# UNITED STATES PATENT AND TRADEMARK OFFICE

10/556,802

## Office Action Summary

## **DETAILED ACTION**

*Prior Art: Matsushita Figure 6*

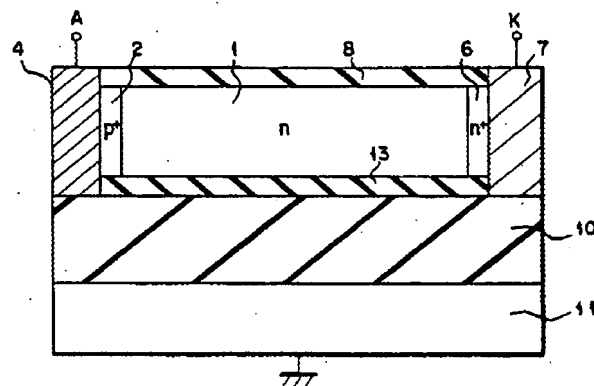
15. Per **Claim 1** Matsushita (e.g. figure 6) discloses a semiconductor device, including

- a semiconductor region having a pn junction (between n-(1) and p-(2)) and
- a field shaping region ((8) and (13)) located adjacent the pn junction,
- wherein the field shaping region ((8) and (13)) is insulating material and is coupled to first (4) and second (7) capacitive voltage coupling regions. (column 4 lines 65-69 discloses that regions (8) and (13) can be  $\text{TiO}_2$ , which is an insulating material)

18. Per **Claims 2 and 3** Matsushita (e.g. figure 6) discloses the device of claim 1, including where the field shaping region ((8) and (13)) insulating material has a dielectric constant greater than that of both silicon dioxide and silicon nitride. Matsushita (column 4 lines 65-69) discloses that regions (8) and (13) can be “TiO<sub>2</sub> or BaTiO<sub>3</sub>, or the like” which both have dielectric constants greater than that of both silicon dioxide and silicon nitride. (“Permittivity (Dielectric Constant) of Inorganic Solids” in *CRC Handbook of Chemistry and Physics, Internet Version 2007, (87<sup>th</sup> edition)*, David R. Lide, ed., Taylor and Francis, Boca Raton FL is provided as a teaching reference )

20. Per **Claim 6** Matsushita (e.g. figure 6) discloses the device of claim 1, including where the insulating field shaping region is adjacent and bridges both the p side and the n side of the pn junction. (see figure 6).

23. Per **Claim 9** Matsushita (figure 6) discloses the device of claim 1, including where at least one of the first (4) and second (7) capacitive voltage coupling regions comprises one of the p and n semiconductor regions which form the pn junction. (see figure 6).

24. Per **Claim 10** Matsushita (figure 6) discloses the device of claim 1, including where at least one of the first (4) and second ((6) and (7)) capacitive voltage coupling regions comprises a more highly doped semiconductor region (6) of the same conductivity type and adjacent one of the p and n semiconductor regions which form the pn junction. (see figure 6).
